**CHICAGO O’HARE INTERNATIONAL AIRPORT
ORDER Up REQUEST FOR PROPOSALS (RFP) FOR “CONCESSION
OPPORTUNITIES IN TERMINALS 1 AND 3”**

Addendum #8 – Answers to Additional Written Questions Opportunity – Full Set

Dated: February 6, 2025

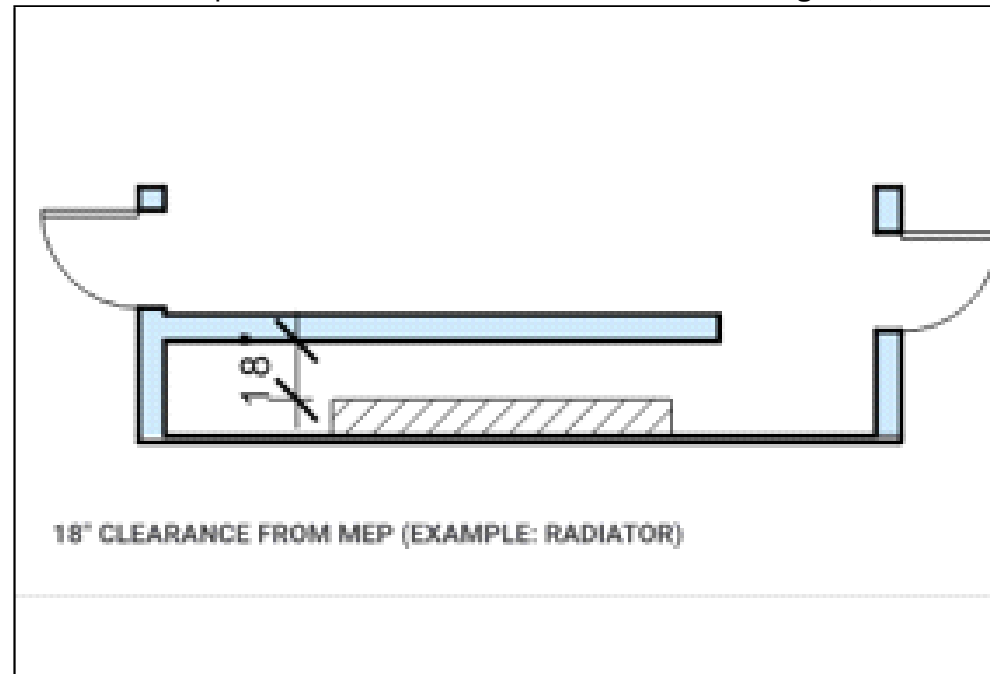
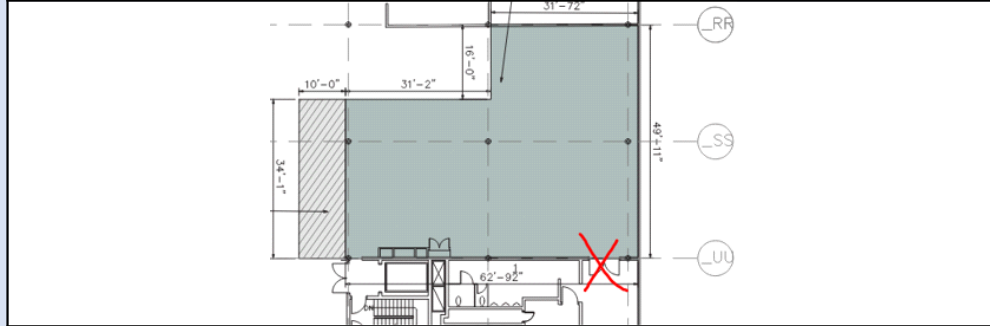
56. [Related to the following Space IDs: T1.B.U.98.A, T1B.U.98.C, T1B.U.EC.A, T1C.U.6.H, T1C.U.13.B, T1C.U.13.C, T1C.U.20.D, T1C.U.31.D, T1.C.U.32.J, T1C.U.33.B, T1C.U.38.D, T1C.U.39.B, T1C.U.44.C, T1C.U.44D]
1. The response to questions regarding tenant clearance distance from the exterior curtainwall at a mechanical floor diffuser does not match the minimum clearance depicted in the Design Criteria.
 2. The existing floor diffusers are 18" deep (front face of floor diffuser to glass). The Criteria requires an additional 18" of clearance in front of the diffuser (per sketch inset)- resulting in a loss of 36" of space across the whole width of many lease spaces, correct??
 3. OR if the response is correct at 18" clearance from the glass, is the Criteria incorrect and needs to be revised?

18" is the minimum clearance required from airport window mullions. CDA may direct the concessionaire to make additional clearances for other building elements adjacent to the curtain wall. Decisions will be made on a project-by-project basis, considering the unique circumstances of each location.

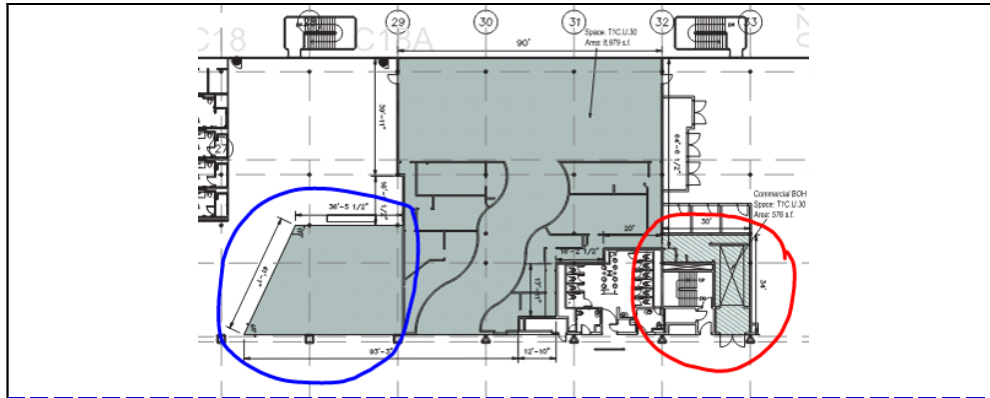
57. [Related to Space ID T1B.U.113.B] Why won't the LOD be corrected to depict the lack of rear service doors? This has a big impact on the exit distances and play layout permitted by Code. See red "X".

The extent of development is to be within the boundaries defined by the LOD. The Architect of Record & Tenant will verify the LOD in the field. Any discrepancies will be corrected following field verification.

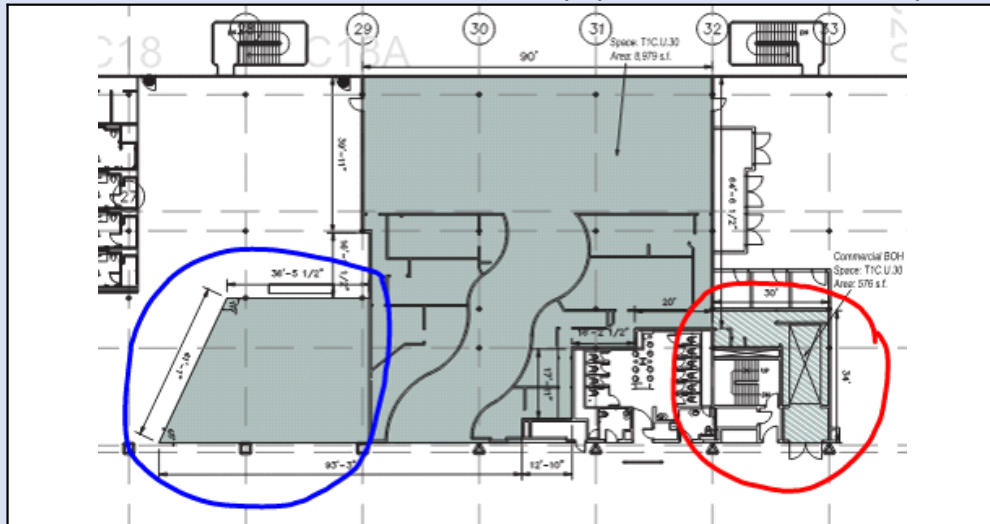
58. [Related to Space ID T1C.U.30] Shouldn't the bidders know that the primary central computer room for United Airlines is directly beneath the food court? Thus requiring extra drain pan protection under all the under slab plumbing?

The Architect of Record & Tenant will be responsible for verifying field conditions. Depending on the proposed design and locations of plumbing lines, a drain pan and leak protection measures will likely be required. The CDA will review all design decisions during the design review process.

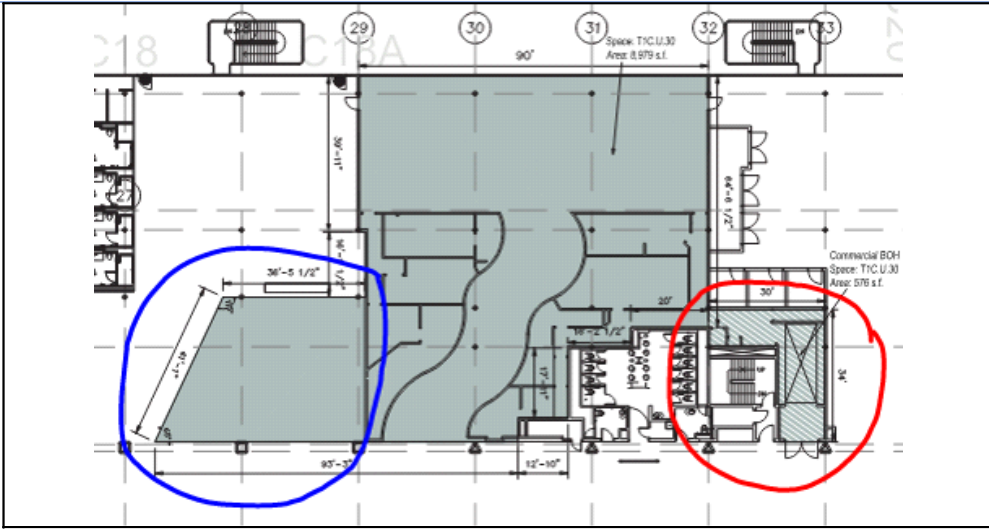
60. [Related to Space ID T1C.U.30] The existing T1 food court tenants have remote dry and refrigerated storage. Will there be new remote storage available for the new tenants?

Remote storage is limited and will be allocated based on availability, tenant occupancy requirements, and leased space.

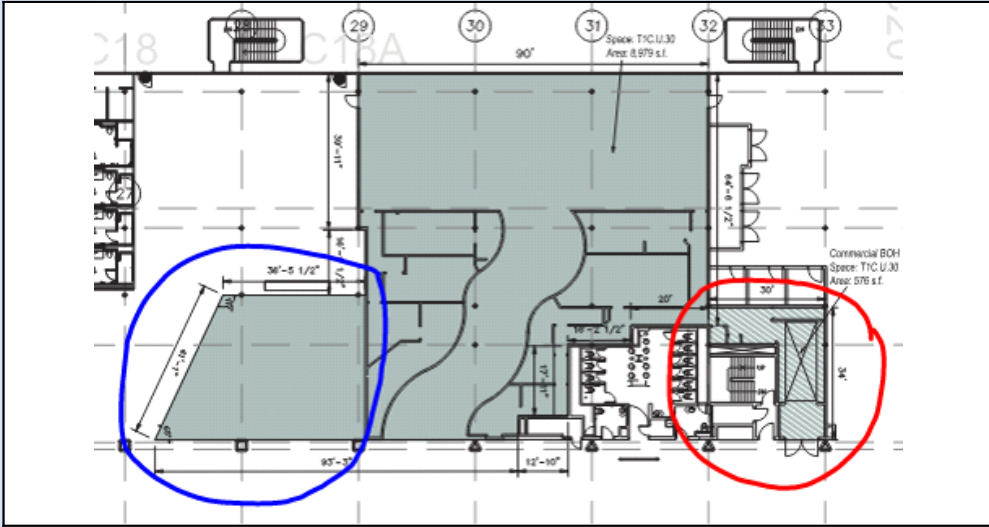
61. [Related to Space ID T1C.U.30] Can the new food court development retain some of the existing demising layout of the existing tenants? or does Aviation expect a completely new layout?

The extent of development is to be within the boundaries defined by the LOD. The CDA will review all design decisions during the design review process.

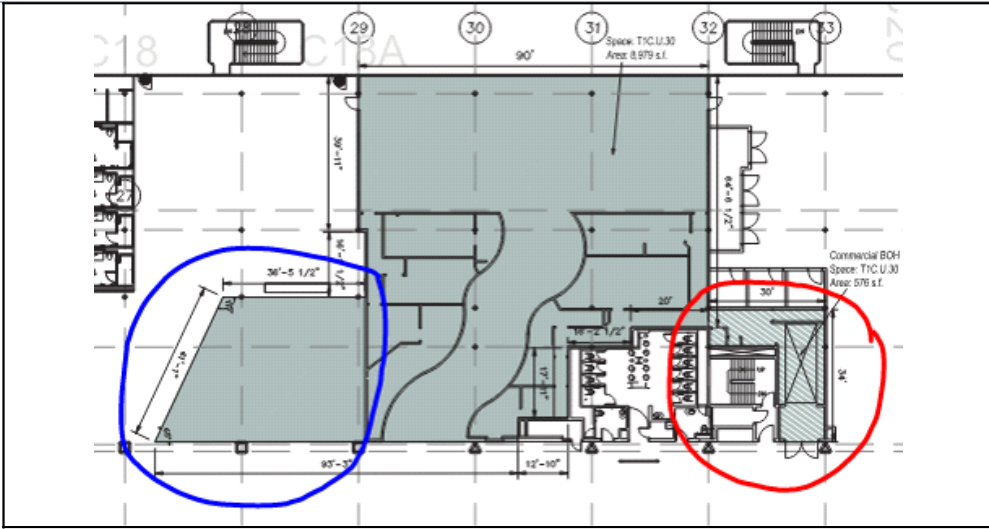
62. [Related to Space ID T1C.U.30] * Does the 'Commercial BOH' shown hatched include a freight elevator used by all terminal tenants (airlines and concessions)? (red outline)
* Will the expenses to maintain and upgrade this freight elevator be a new tenant cost?

No, the CDA will be responsible for elevator maintenance.

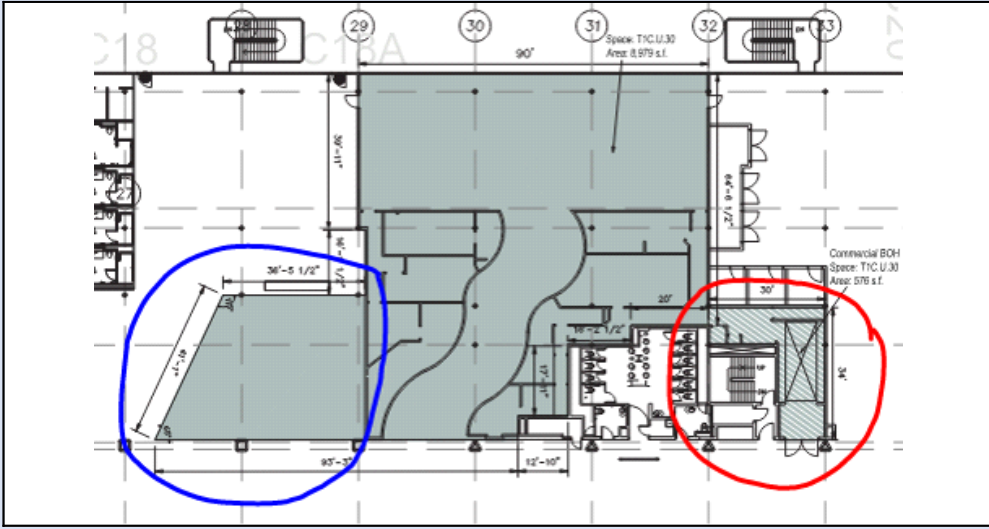
63. [Related to Space ID T1C.U.30] Will the expenses to maintain and upgrade this freight elevator be a new tenant cost?

No, the CDA will be responsible for elevator maintenance.

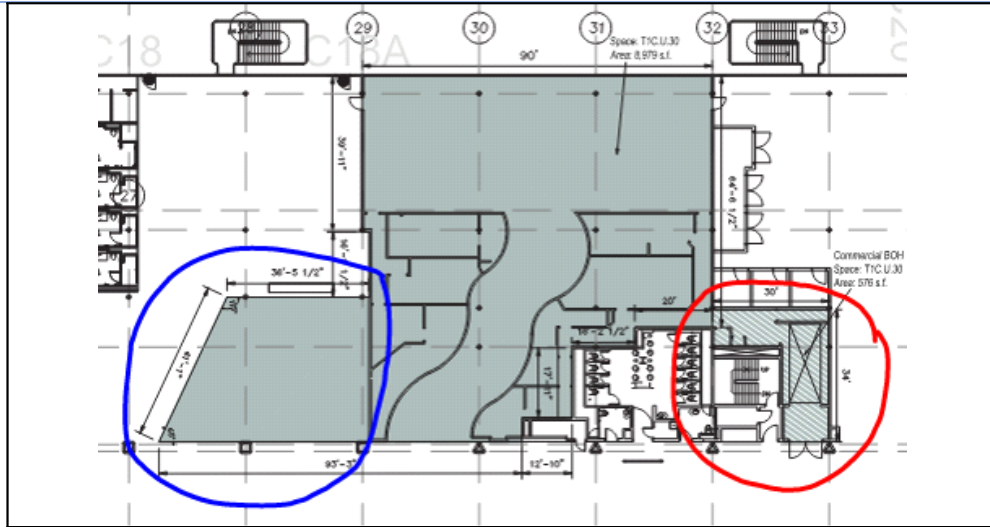
64. [Related to Space ID T1C.U.30] Will the new 'master' tenant be responsible for all cleaning and maintenance costs if CDA does not cover any future CAM charges?

Refer to ORD Up!, Section V, B: Compensation to the City (Additional Rent) and Section H: Utilities and General Maintenance (Maintenance) for further details.

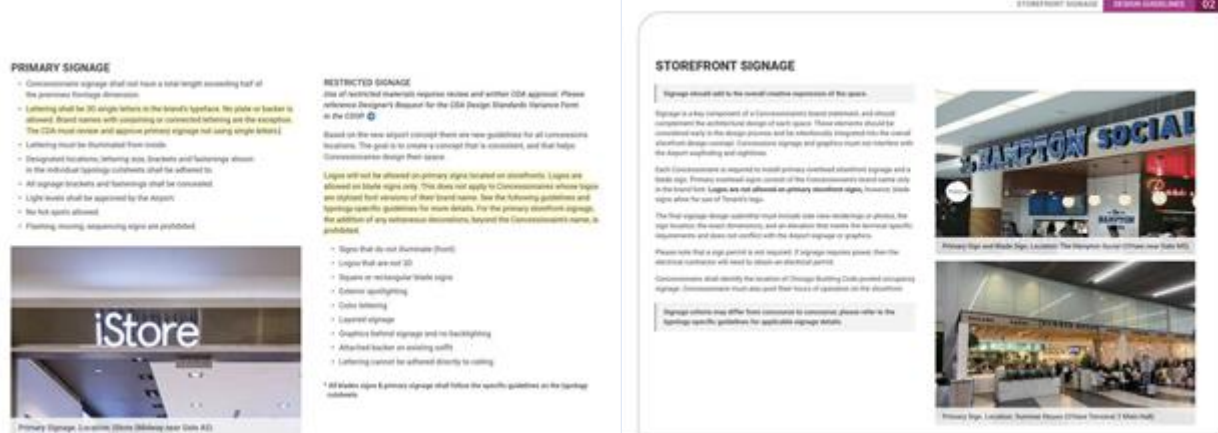
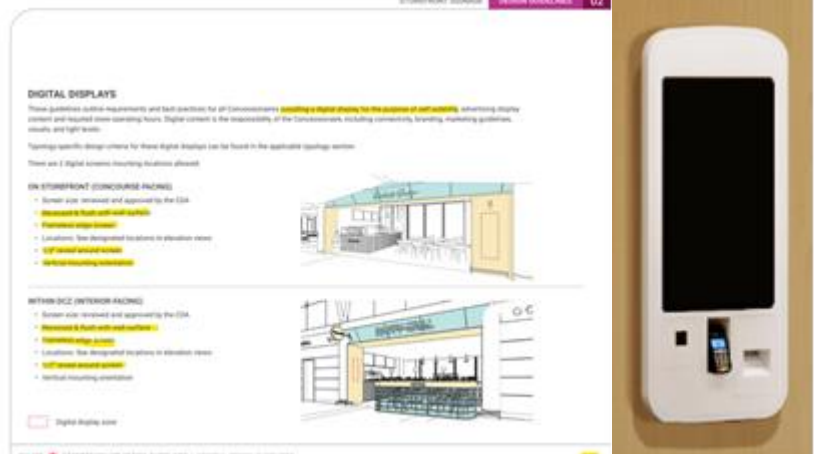
| 71. | Are we to interpret the following that if our logo has an emblem, we are not permitted to use it on the storefront signage, for example the “Wendy” to the right is not permissible? Only the text?  | Logos are not permitted on the primary storefront signs, but are permitted on blade signs. See page 1-27 of the Design Guidelines in the Data Room. |
